6.0 ADMINISTRATIVE CONTROLS

8706180020 870612
PDR ADOCK 05000400
P PDR

FIGURE 6.2-1
OFFSITE ORGANIZATION

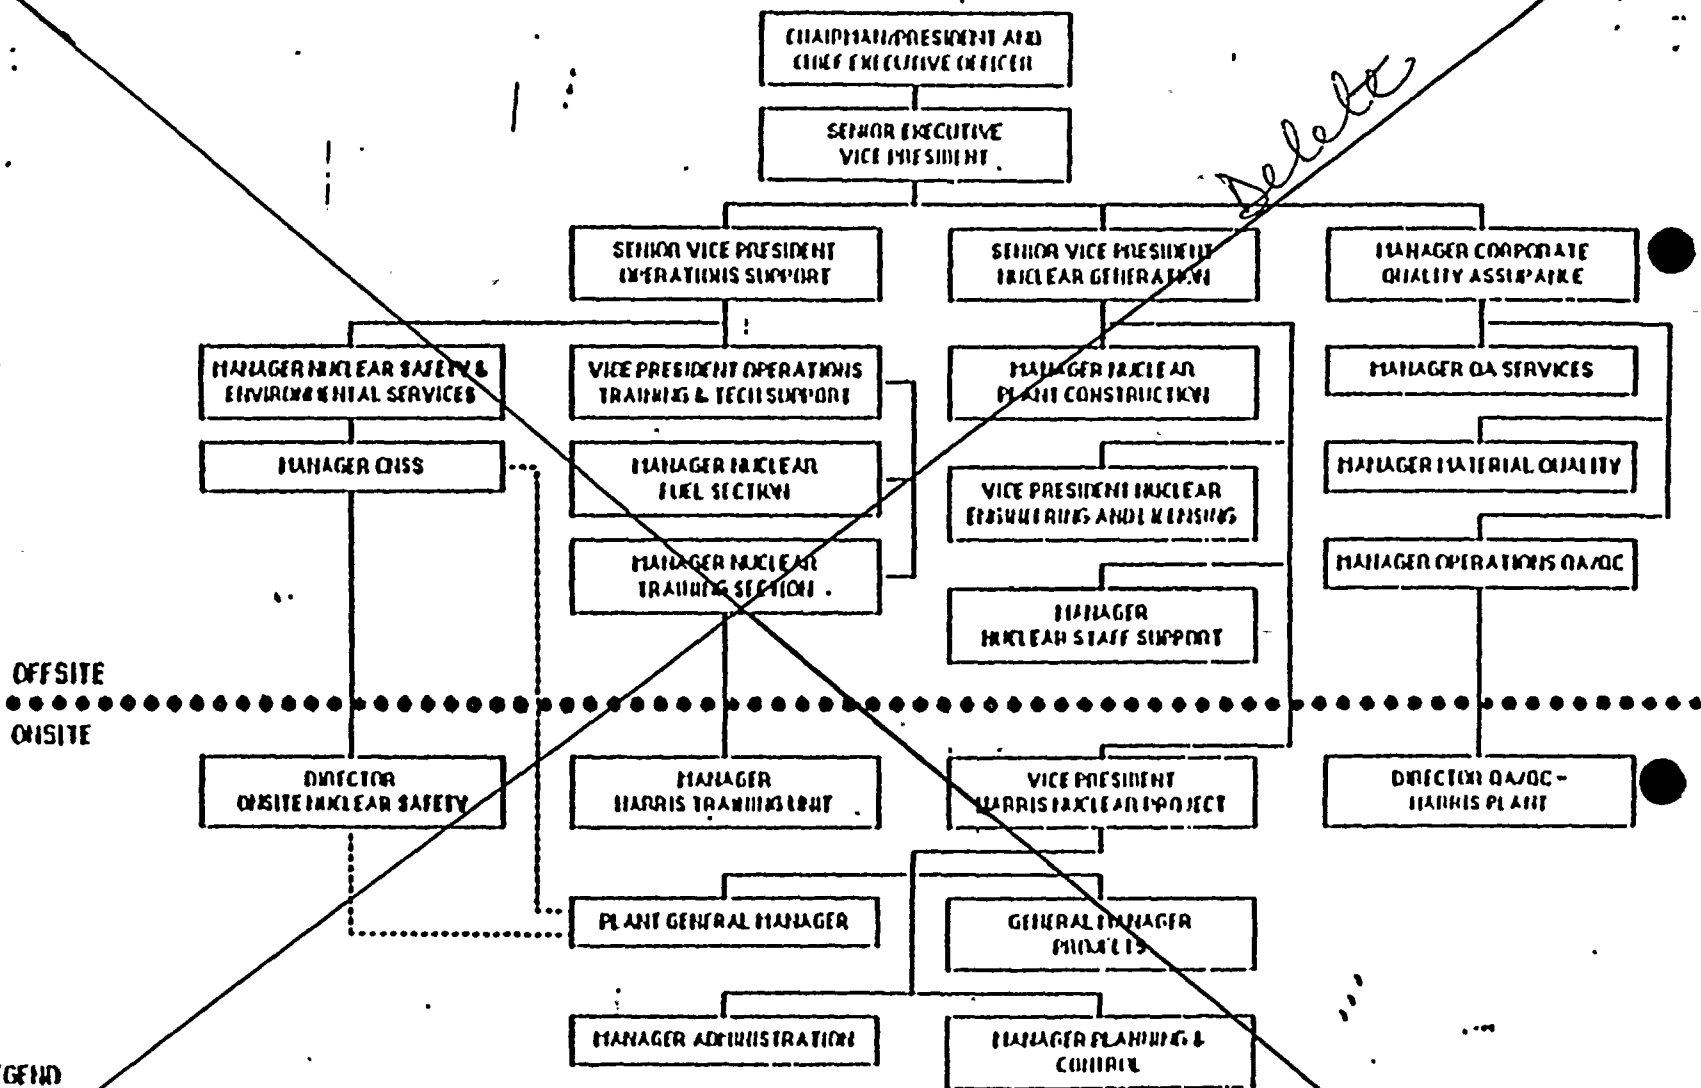
(Deleted).
~~6.2.1 The offsite organization for unit management and technical support shall be as shown in Figure 6.2-1.~~

FIGURE 6.2-2
UNIT ORGANIZATION

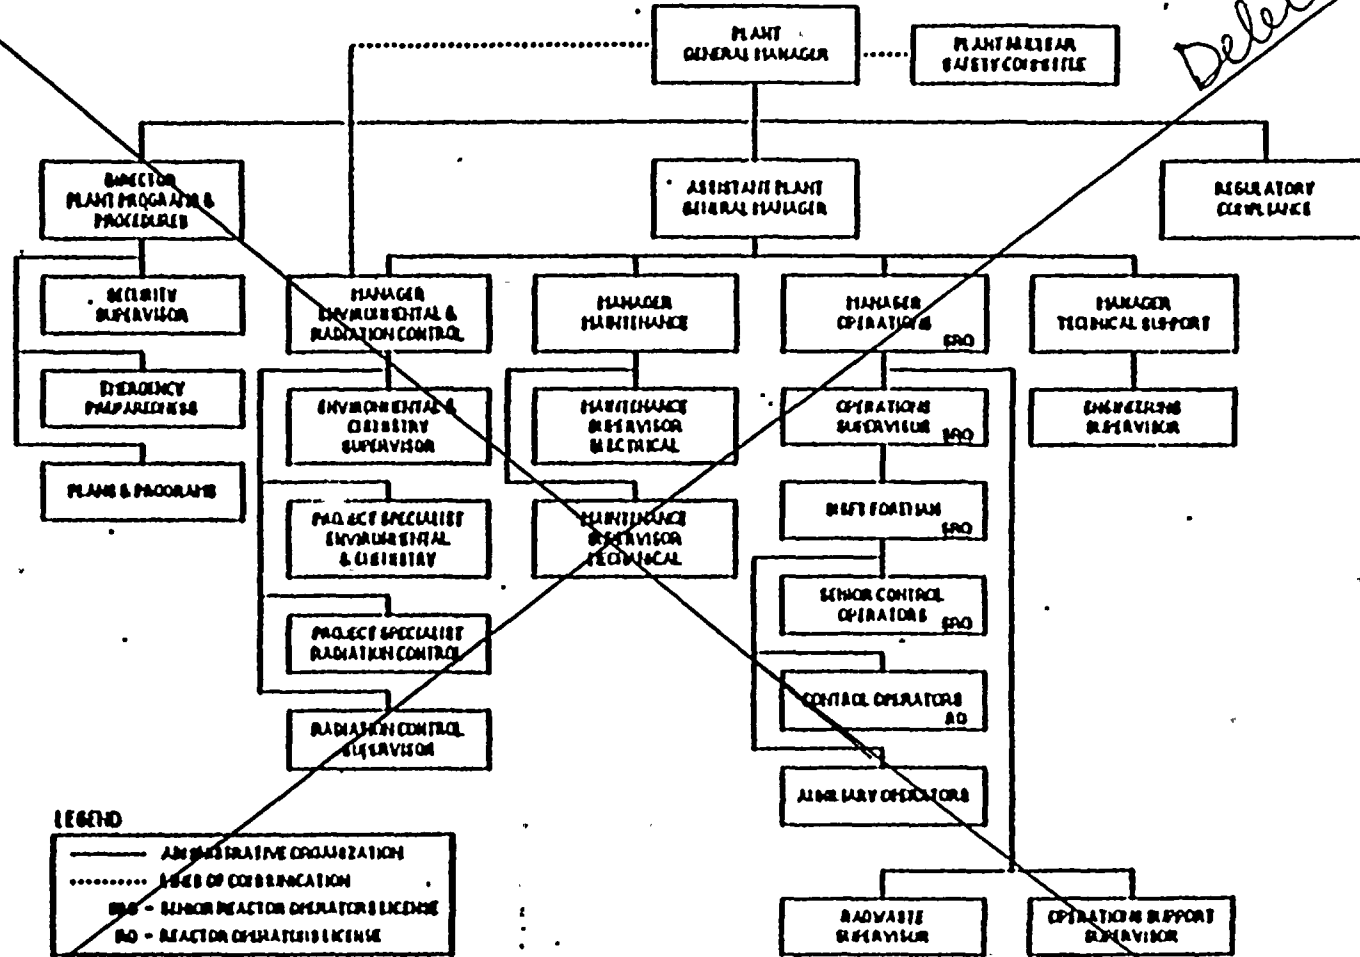
6.2.2 The unit organization shall be *subject to the following* ~~as shown in Figure 6.2-2 and~~.
